TECHNICAL SERVICE BULLETINS

SERVICE BULLETIN

APPLICABILITY: STi Vehicles, All Model Years
SUBJECT: Towing Recommendations

NUMBER: 01-162-05
DATE: 06/28/05

Old Disk Brake Kit: 26692FE040/050 (LH/RH)

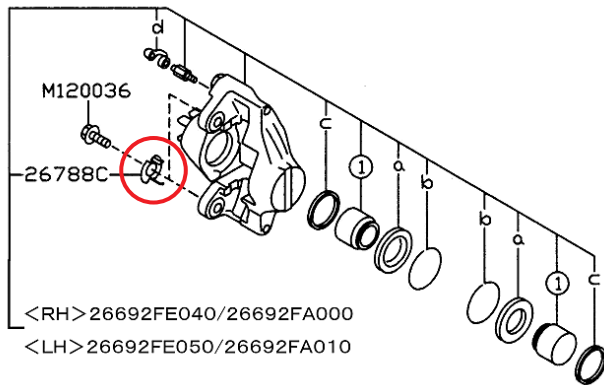
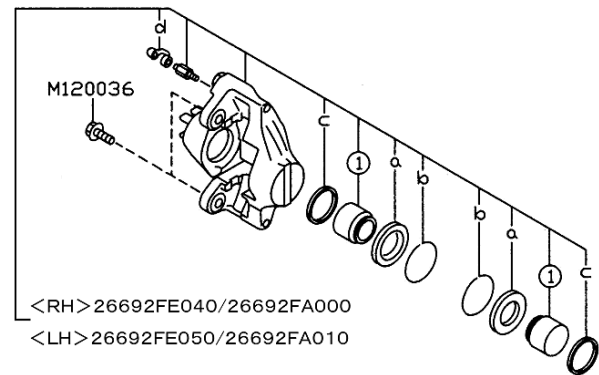
A production change was made to the rear brake caliper on 01MY and newer Impreza WRX. The washer between the caliper body and the backing plate has been discontinued. A change has been made to the caliper body to maintain the correct geometry, although the part numbers have not changed.

Note: Though there were design changes made to this part, the part numbers remain the same.

New Disk Brake Kit: 26692FE040/050 (LH/RH)

CENTER HORN
New 86012FE040 (Low)
Identification: UCL-202<Inscribed>

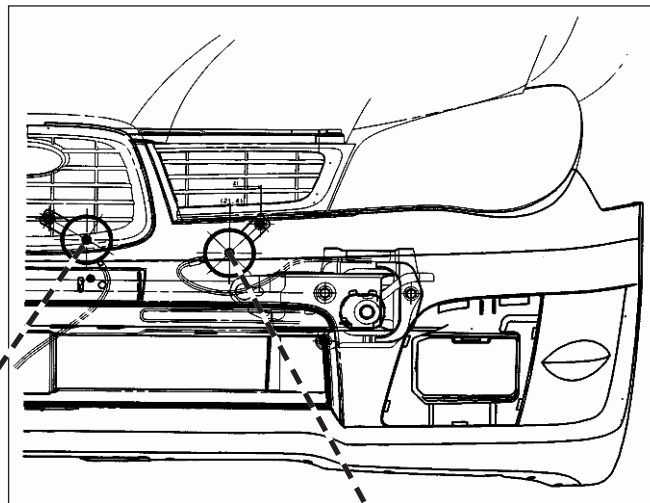
This bulletin informs of a change in the external diameter of the horns from 76mm (3in) to 70mm (2.75in), and the position of the High and Low frequency-type horns.

POSITION	NEW		OLD	
	Tune	Part Number	Tune	Part Number
Center	Low	86012FE040	High	86012FE030
Left side	High	86012FE050	Low	86012FE020

Old 86012FE030 (Hi)
Identification: NMH-201<Inscribed>

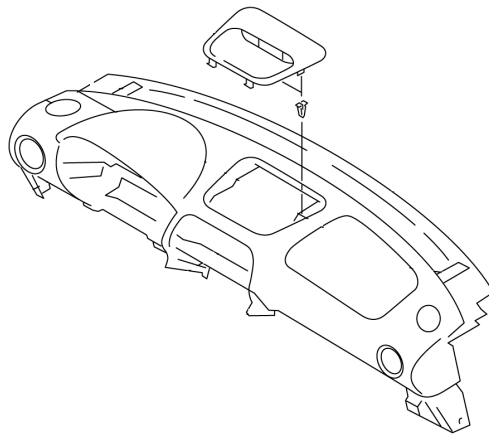
To correct this misjudgment condition, the circuit logic in the clock has been modified so that power will be supplied to the passenger airbag status indicator during cranking.

PART DESCRIPTION	OLD PART NUMBER	NEW PART NUMBER
Auto Clock Assembly	85201FE000	85201FE001

Check the part number of the clock currently installed in the vehicle. If equipped with the old style, replace it with the new style.
